Parkhill Interconnect Comparative Layout - East

4.0 Amendments to the Records Review

Figure 2c

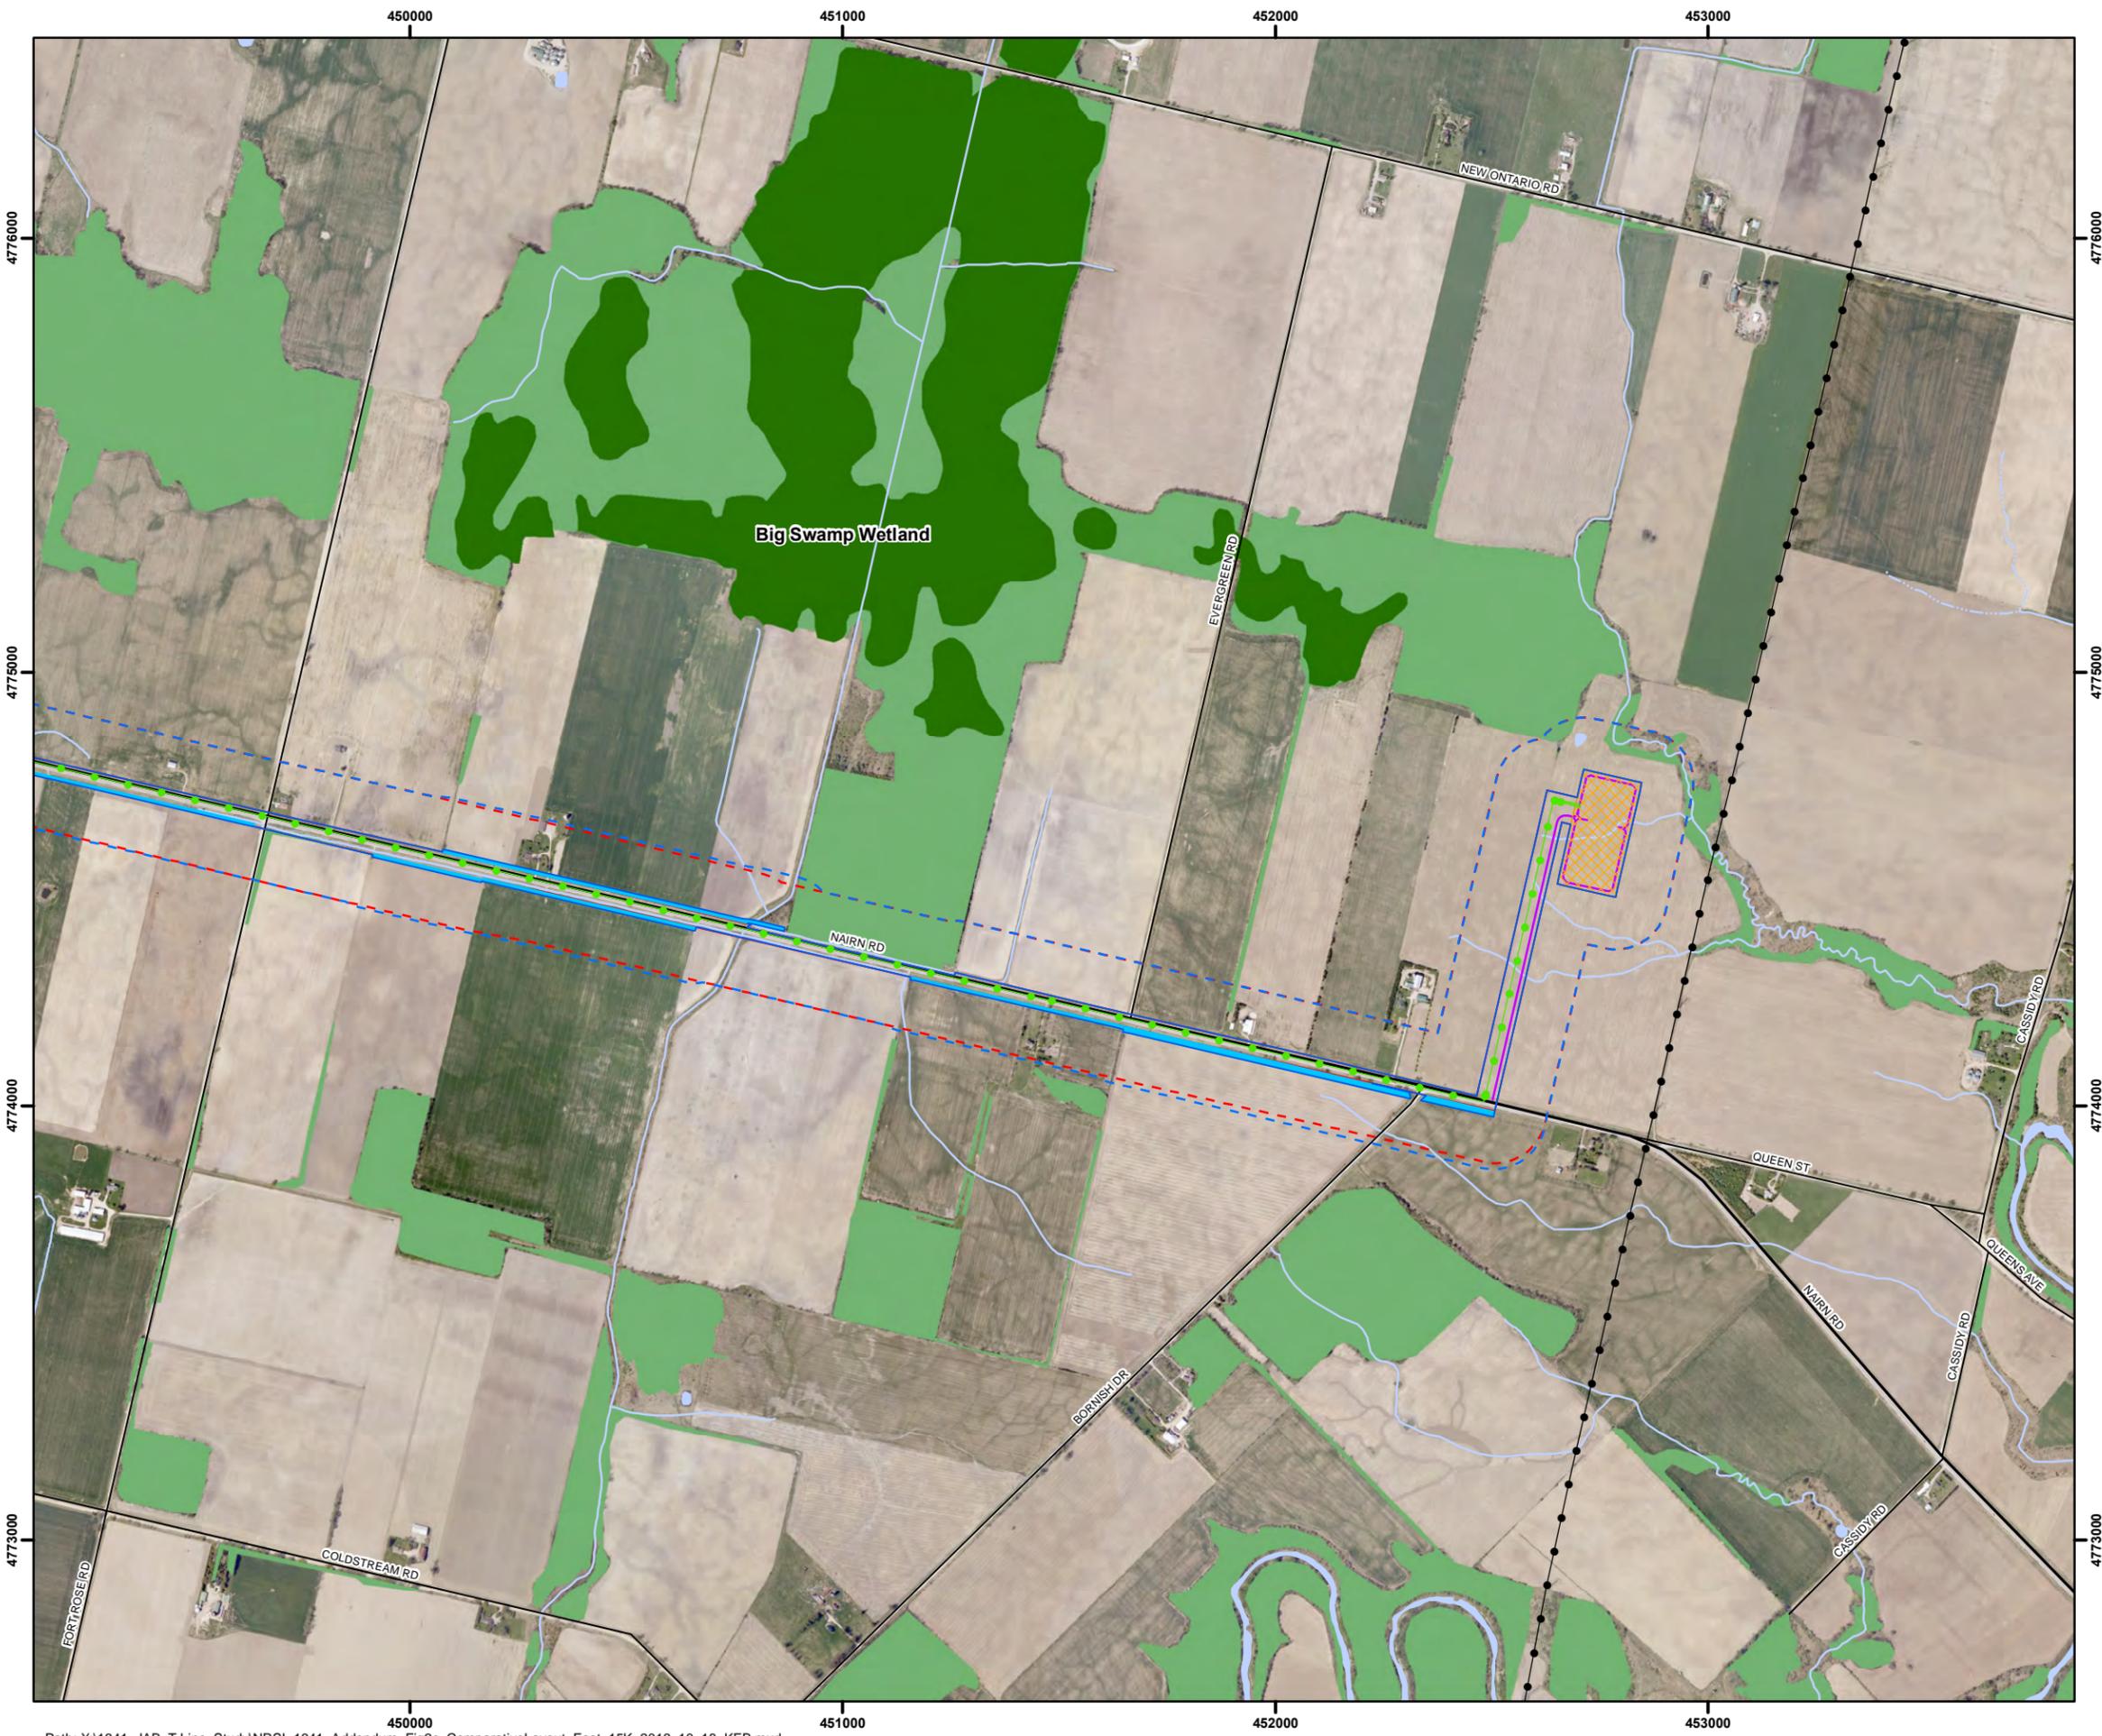
Given the changes in project location, described and mapped above, NRSI has identified where the distance of the project location to a natural feature has changed. These changes in distance have been outlined below in Table 1 and include the feature identification number, feature type, and comparison of distances from project location to natural feature between the presented layouts. Six natural features, (woodlands), resulted in having a change in distance from the project location.

Two woodlands (WOD-045 and WOD-004) that were previously located near, but not overlapping, the project location are now overlapped by the proposed disturbance area for the transmission line. Although vegetation removal will be kept to a minimum within the footprint, the total extent of vegetation removal that would occur, should the entire project location be used, is shown in Table 2. Appropriate mitigation measures, monitoring commitments, and other applicable measures to prevent significant impact to these features can be found in Table 4.

Figure 3

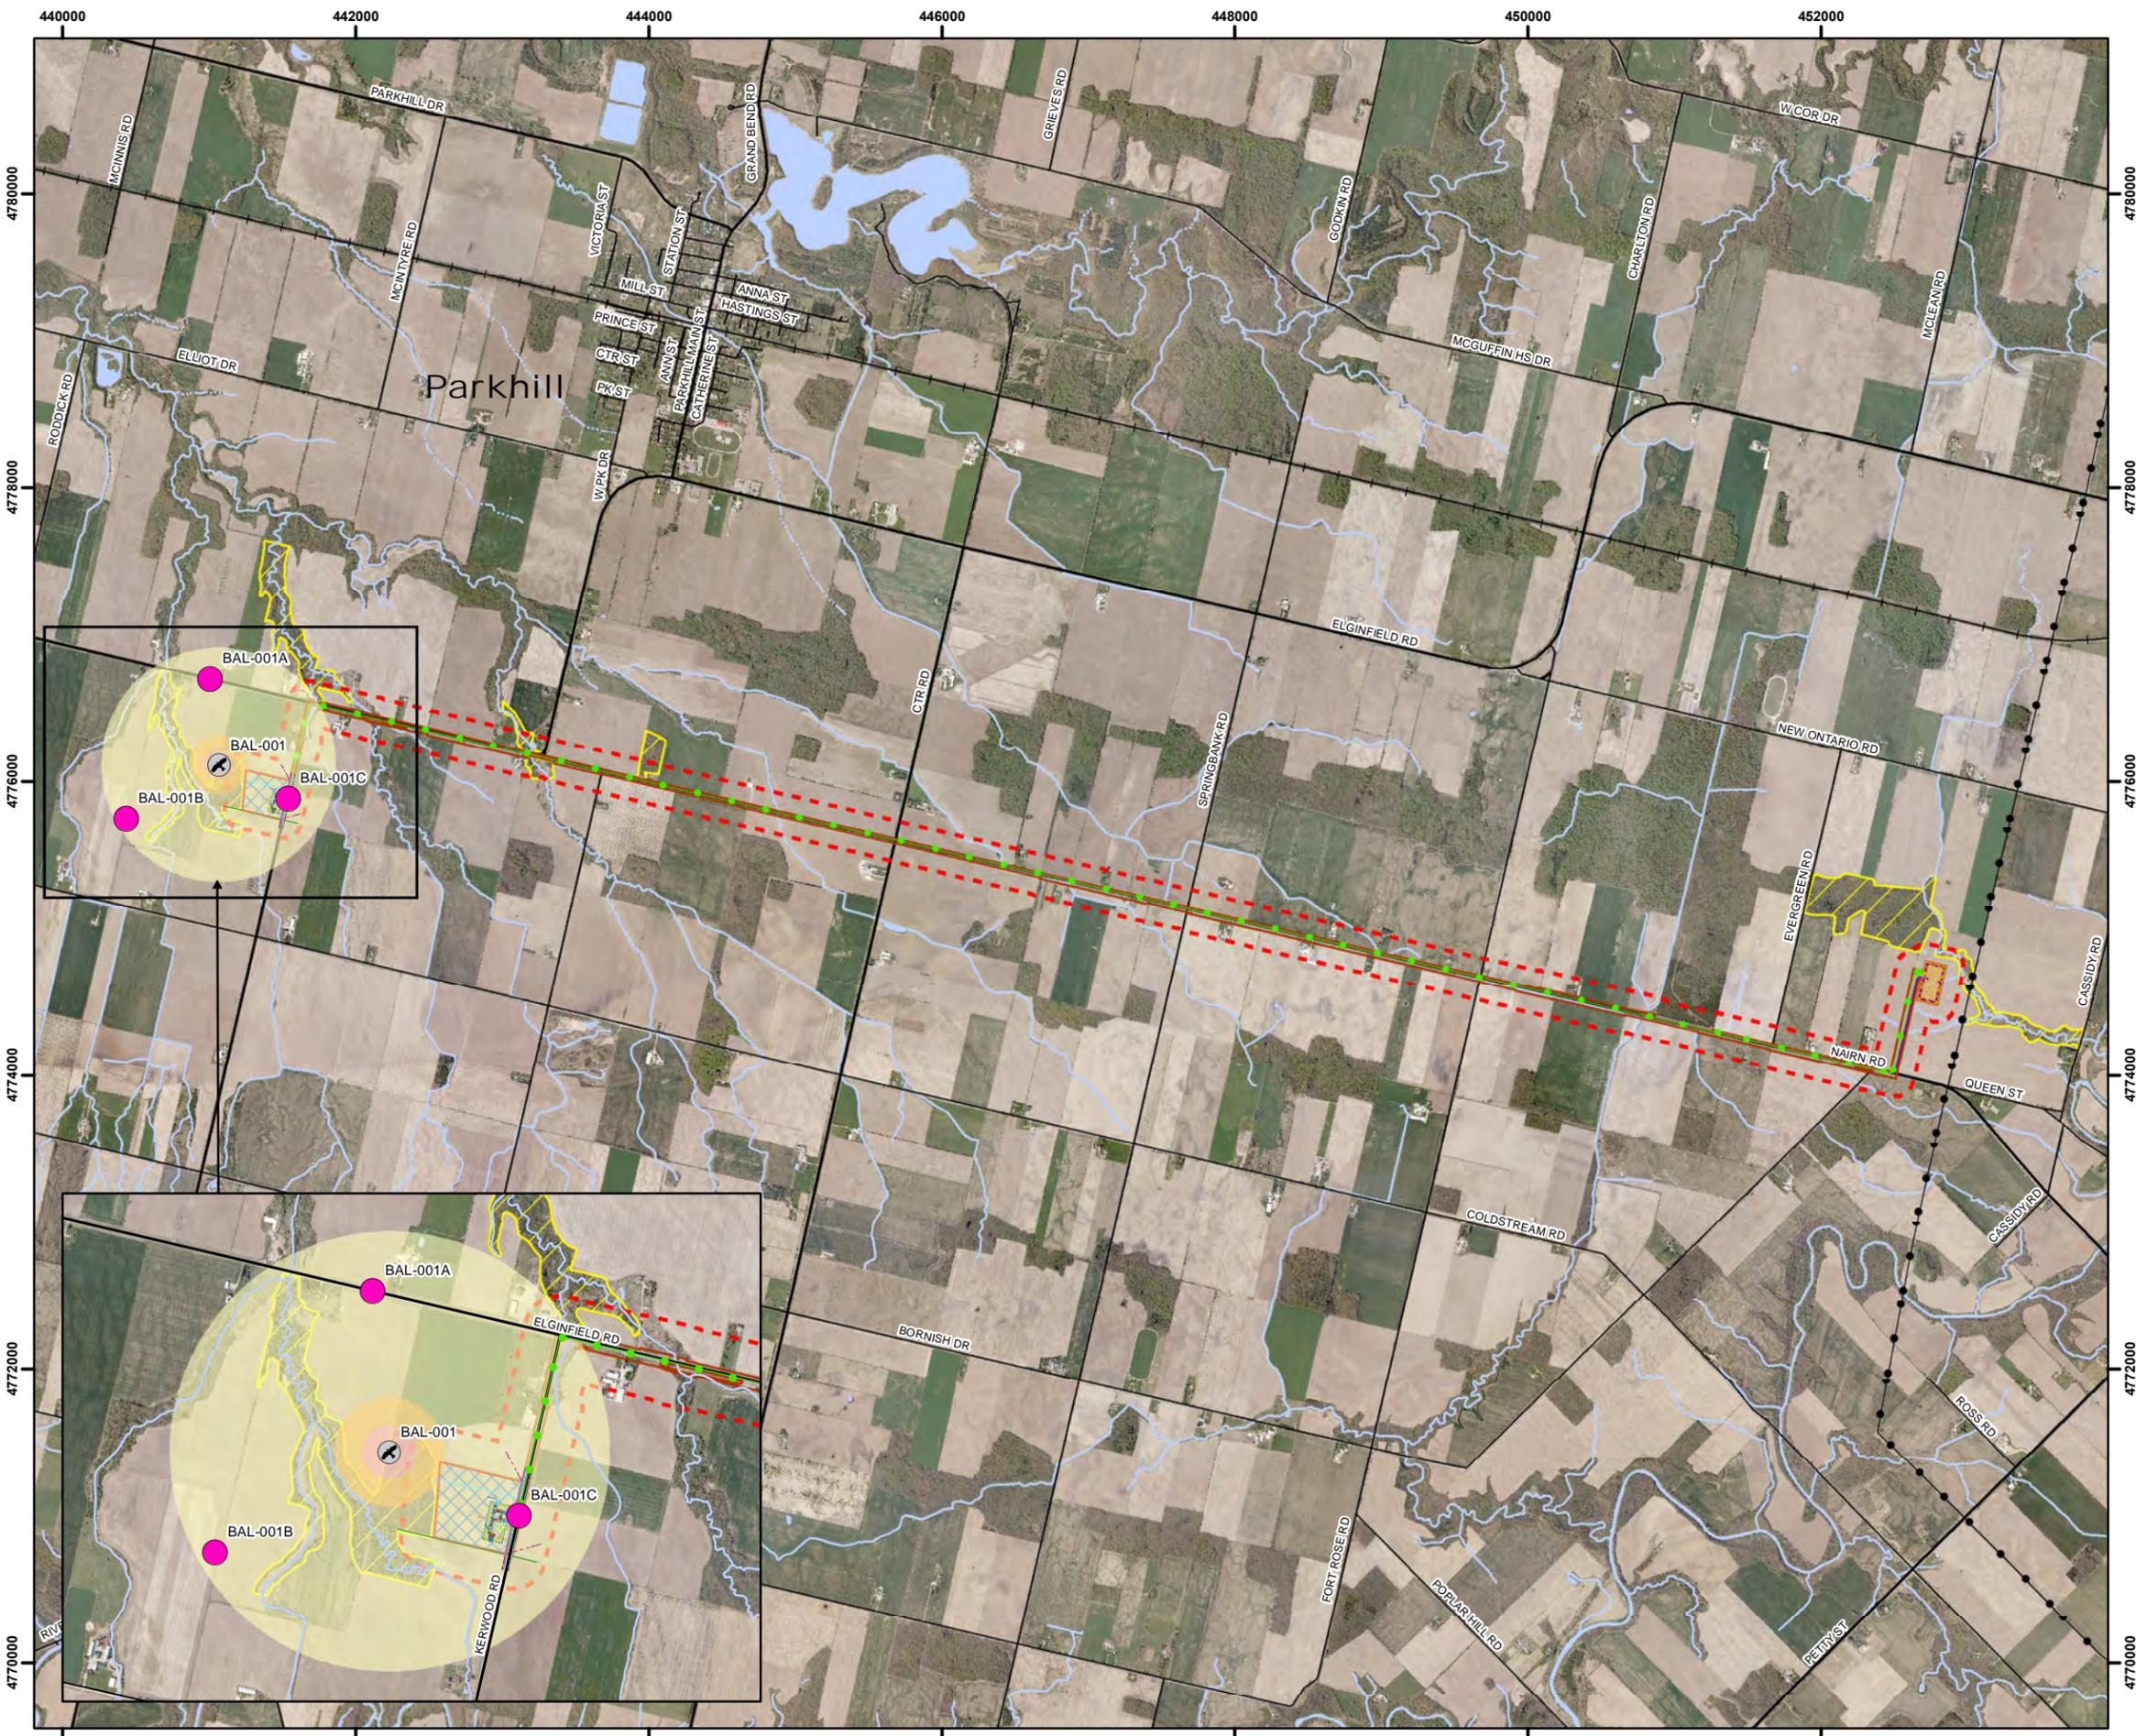
Based on changes in distances to project location, certain wildlife habitats could no longer be considered Generalized Significant Wildlife Habitat. Further site investigation in September 2013 of the potential wildlife habitats within features WOD-004, WOD-045 and the southern portion of WOD-048 have resulted in the removal of some of the generalized wildlife habitat designations (see Table 3). The entire area of WOD-004 and WOD-045 and the southern portion of the area previously delineated as WOD-048 are no longer considered generalized significant wildlife habitat. These further site investigations, following the same methods as outlined in the approved *Parkhill Interconnect Natural Heritage Assessment Report* (NRSI 2013), indicate there are no candidate significant wildlife habitats within these features. Field notes from the field visits conducted in 2013 have been included in Appendix II. See Figure 3 for updated generalized significant wildlife habitat mapping.
